Virtual Committee of Adjustment
Meeting
October 23, 2024 at 1:00 pm

HEARING NO. 5.1 - 1:00 P.M.

File**540-02-A-025/24**

PROPOSAL: The applicant is proposing the construction of a 28-storey mixed-use building including mechanical penthouse, with ground floor commercial fronting onto Old Lakeshore Road and indoor amenity area fronting onto Lakeshore Road. Five levels of below grade parking, at grade amenity area and patio and internal associated amenity areas are also proposed.

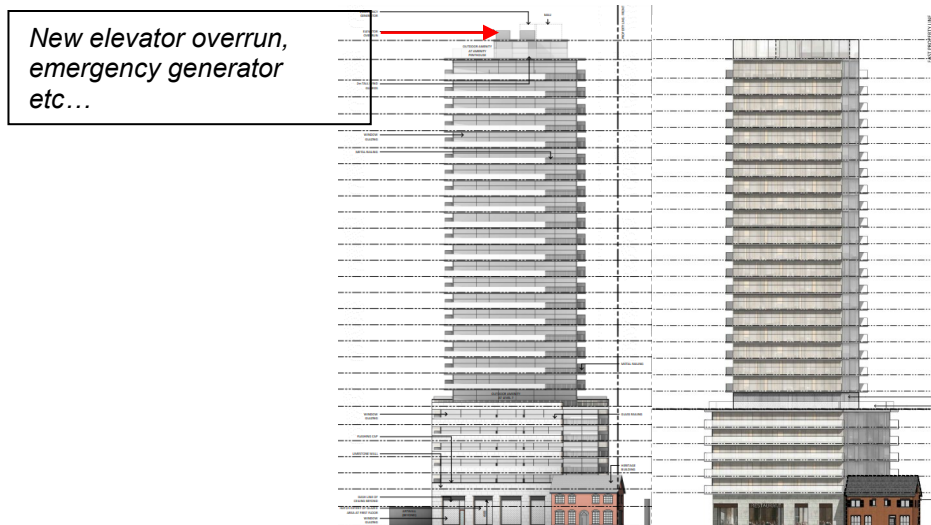
Staff consider the addition of indoor amenity area to the rooftop level to be a minor numerical variation to the OP, which meets the Plan’s general intent and purpose. The lands are located within the “Downtown Mixed-Use Centre”, in accordance with ‘Schedule B – Comprehensive Land Use Plan – Urban Planning Area’ of BOP 1997, as amended and is further designated as “Old Lakeshore Road Mixed Use Precinct” (OLRMUP), in accordance with ‘Schedule E – Downtown Mixed-Use Centre’ of BOP 1997, as amended. The OLRMUP is divided into three sectors: west, east and south. The subject lands straddle the east and west sectors and the proposal is subject to policies for each. Staff note that the approved and proposed height of the building significantly exceeds the heights envisioned in the OLRMUP (Up to 15 storeys), but is consistent with a series of OLT decisions for properties in the immediate area, which have confirmed that heights of between 28 storeys (2107-2119 Old Lakeshore Road) and 29 storeys (2069-2079 Lakeshore Rd.) are appropriate and conform to provincial policy. In reaching its decision for the subject lands, the OLT considered detailed analysis of elements of this proposal such as land use, design, privacy, sufficiency of amenity space, visual impacts, sun shadowing and wind impacts and other matters. The

OLT was of the opinion that these matters had been appropriately addressed and that a building of approximately the height proposed was appropriate for this area. A comparison of the current version of the building and the OLT-approved version is below to show the similarity between the proposed and approved built form.

Deemed Road Width Analysis

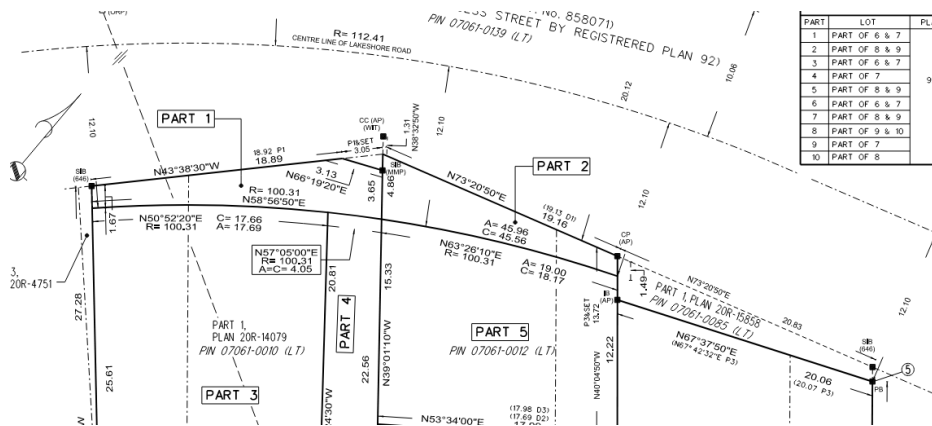
Transportation Planning have reviewed the right-of-way (ROW) requirements for 2093,2097,2101 Old Lakeshore Rd and 2096,2100 Lakeshore Rd.

The deemed ROW at Lakeshore Road is 30m, according to the Zoning By-Law section 2.27, Table 1.2.9. Transportation Planning find it supportable to reduce the ROW to 24m. The ROW conveyance dimension varies throughout the Lakeshore frontage. A $\pm 1.67\text{m}$ to the west end, $\pm 1.49\text{m}$ to the east, and $\pm 3.65\text{m}$ land to the middle of the property are required to convey to the City to measure the deemed width 12m from the center line of Lakeshore Road. The applicants' Ontario Land Surveyor (OLS) shall confirm the exact measurements.

The draft reference plan, dated September 18, 2020, is acceptable.
